In the matter of a proposed plan change to rezone
land at 611 Rangitikei Line to establish
the Whiskey Creek Residential Area

**STATEMENT OF EVIDENCE OF PHILIP LAWRENCE WALLACE
IN SUPPORT OF FLYGERS INVESTMENT GROUP LIMITED
FLOOD ISSUES
18 MAY 2022**

Figure 2: Predicted flood depths, 0.5% AEP flood, existing situation

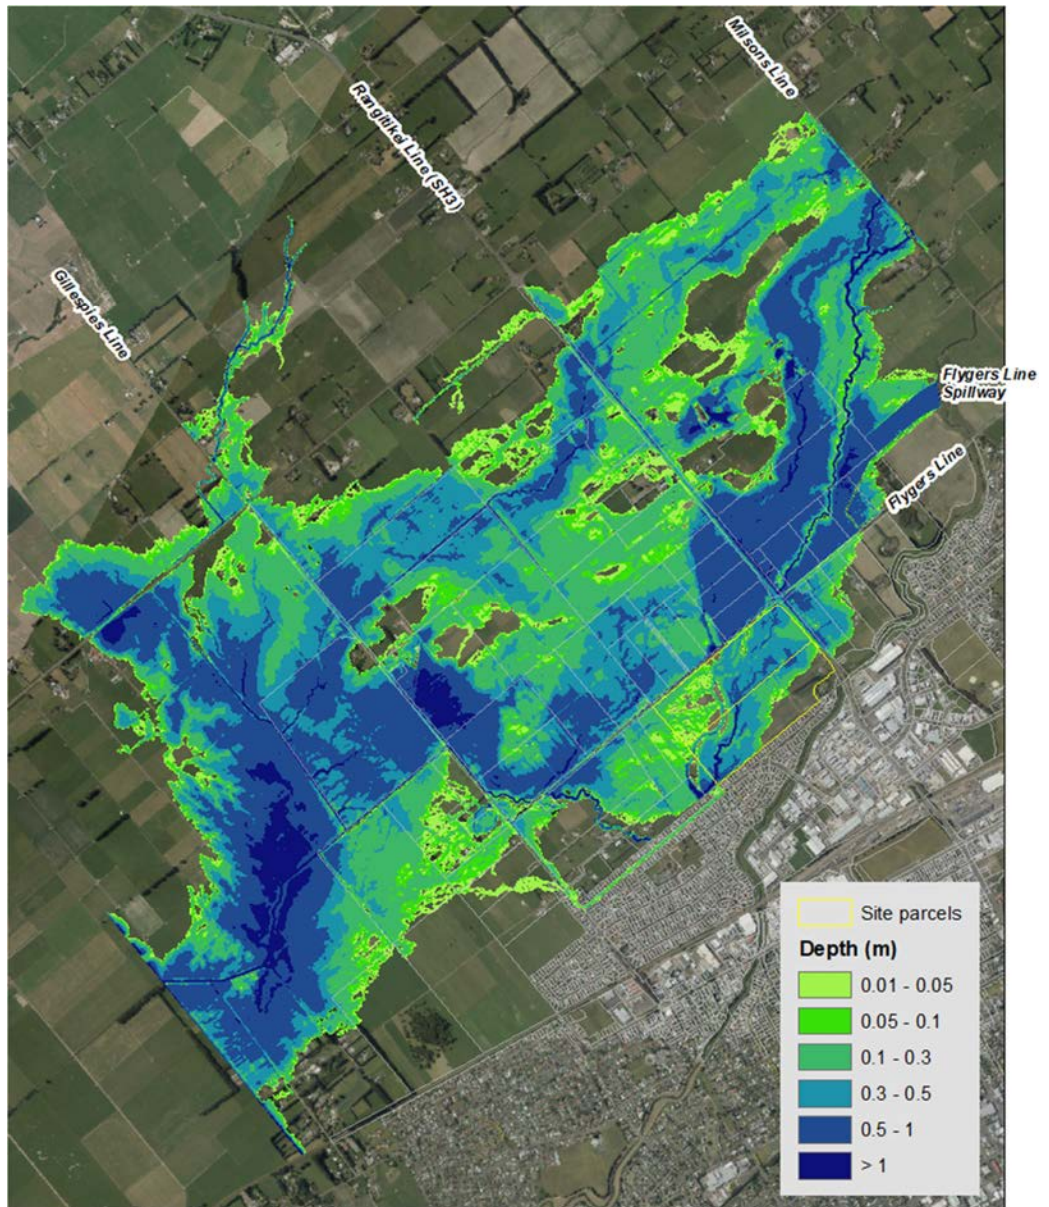
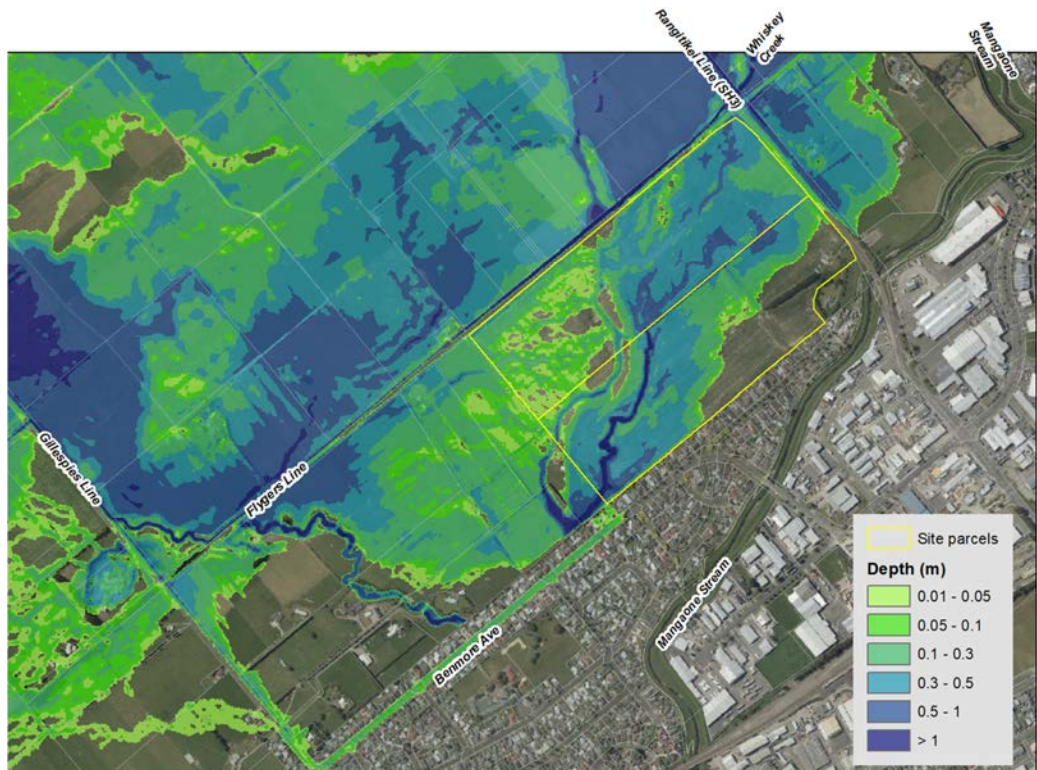
45. Benmore Avenue stopbanks (Preston 4.5g, 4.7d, 4.9, 4.36, Asgar g(vii)): As I have outlined earlier, actual bank levels (or design levels where as-builts were not available) have been incorporated into the most recent modelling. These include the stopbanks upgraded in 2018 and 2019. Option 6 is now shown to lessen the overtopping. Nonetheless, stopbank crest levels behind 99 Benmore Avenue are uncertain and the model may overestimate the spilling. I recommend that additional survey capture the crest level at that location.

Figure 5: Effect of Option 6 on peak flood depths, 0.5% AEP flood

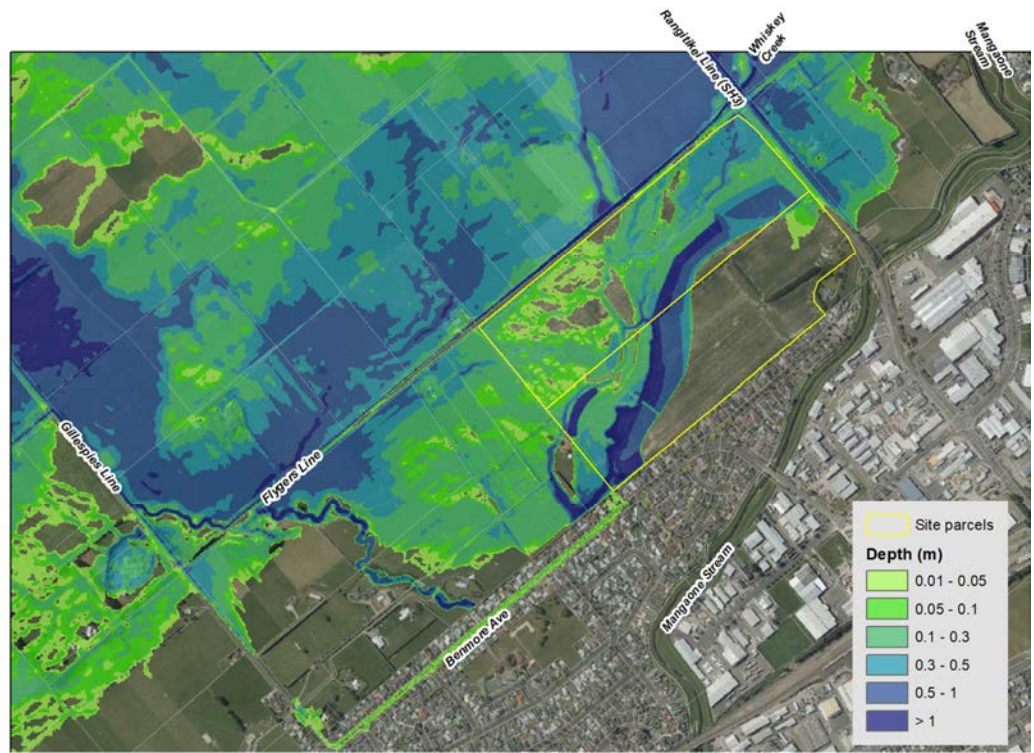
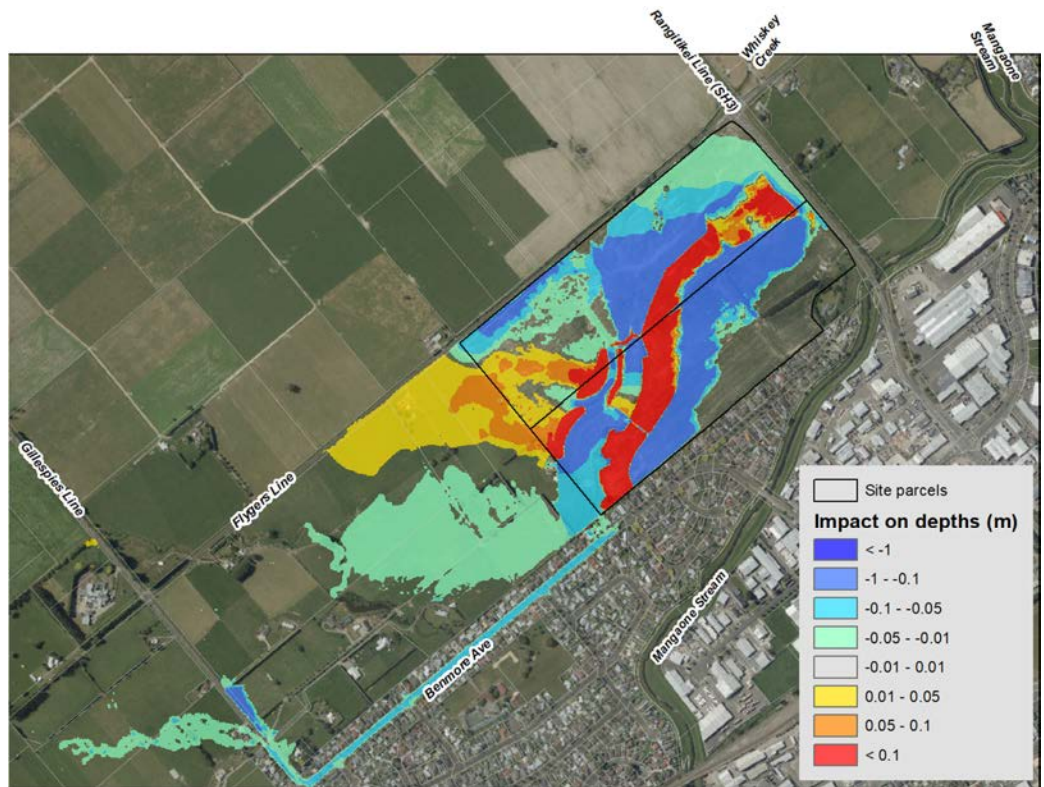
- (a) Modelling results from Option 6 show that this layout option would result in lower flood levels adjacent to the stopbank running at the rear of Benmore Avenue and Meadowbrook Drive properties, for the 0.5 % AEP flood. Although Figure 5 shows an increase in depth behind 103 to 111 Benmore Avenue, this is due to the option having an excavated pond in that reach; actual flood levels are lower.

- (b) Figure 5 also shows a predicted reduction in depths along Benmore Avenue.
 - (c) In the existing case, floodwaters are only predicted against properties south of 5 Meadowbrook Drive; in the proposed case, the floodwaters would only extend as far north as 111 Benmore Avenue.

49. Comments regarding Option 6 (Preston 4.15, 4.16, 4.30, Asgar g(i)): I agree that some modification of Option 6 will be required, especially in light of the latest findings. However, the latest results do indicate a reduction in risk to the Benmore Avenue area.

- (d) Nonetheless, the proposed pond of Option 6 immediately behind the stopbank, between 103 and 111 Benmore Avenue could threaten the geotechnical integrity of the stopbank at that location and compromise the flood protection that the stopbank offers. I would also expect that Horizons would require a maintenance setback. For these reasons, I recommend that any excavation to form a pond be set back at least 10 m from the stopbank toe. A geotechnical analysis would need to form part of the design process.

Figure 6: Peak flood depths for Taonui Basin and the Whiskey Creek models

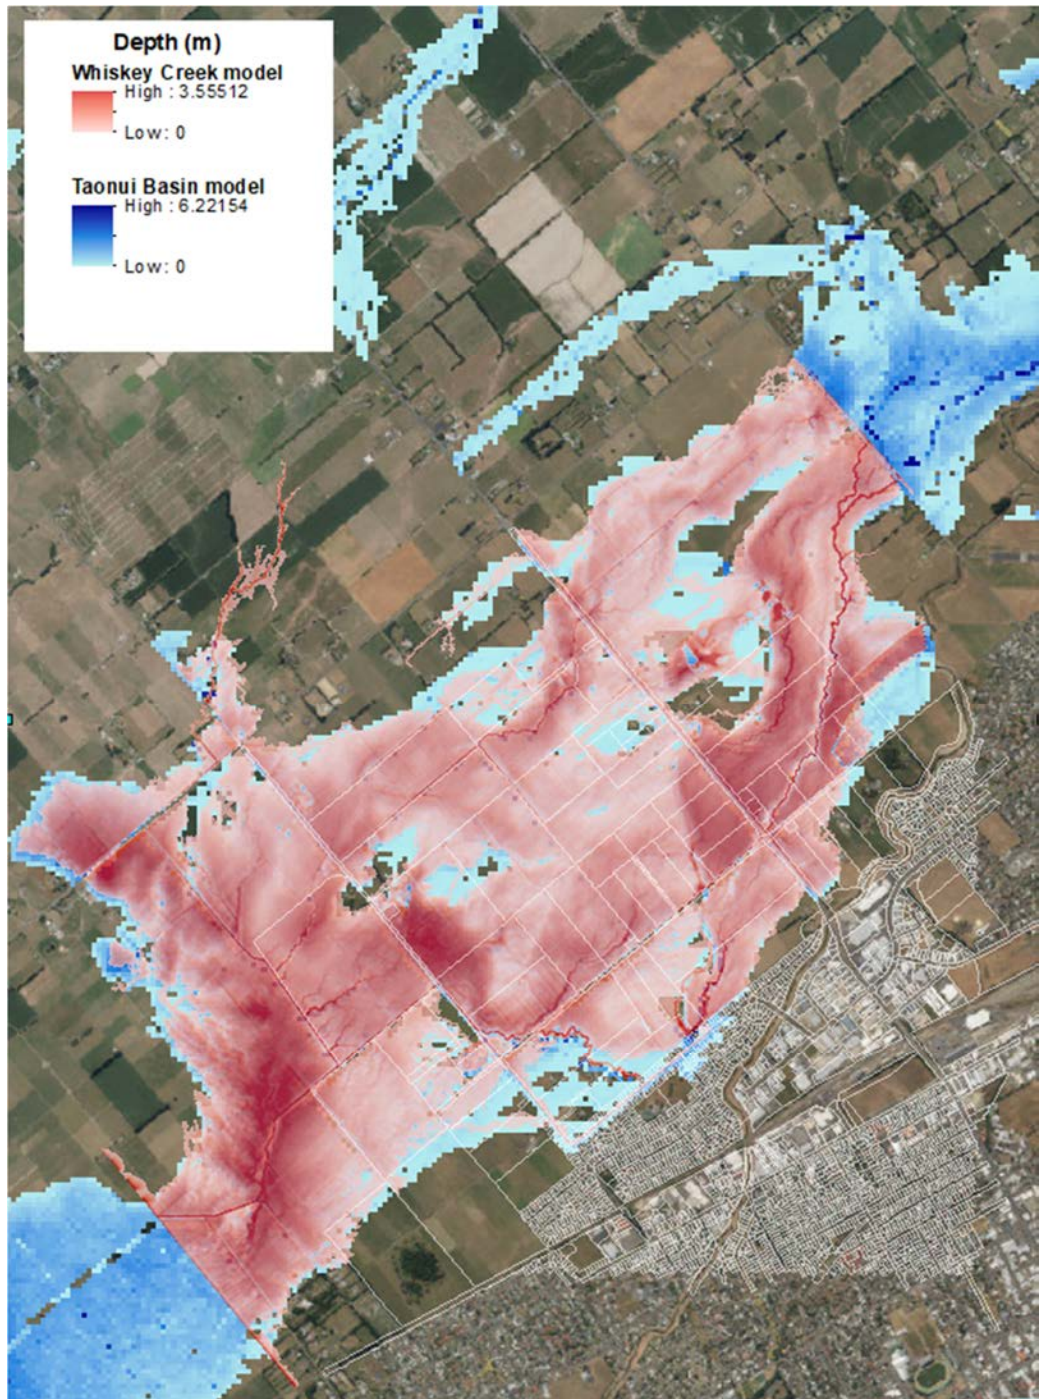
47. Consistency between the baseline flood for the latest (i.e. "Whiskey Creek") model and the regional (i.e. "Taonui Basin") model (Preston 4.5a, 4.7f, 4.31, Asgar g(ii)): (Note that this question appears to have been lost in translation in the conditions recommended by Mr. Asgar.) Figure 6 illustrates that there is consistency between the two models. Differences between the two will in large part be due to the much greater resolution of the ground topography in the Whiskey Creek model.
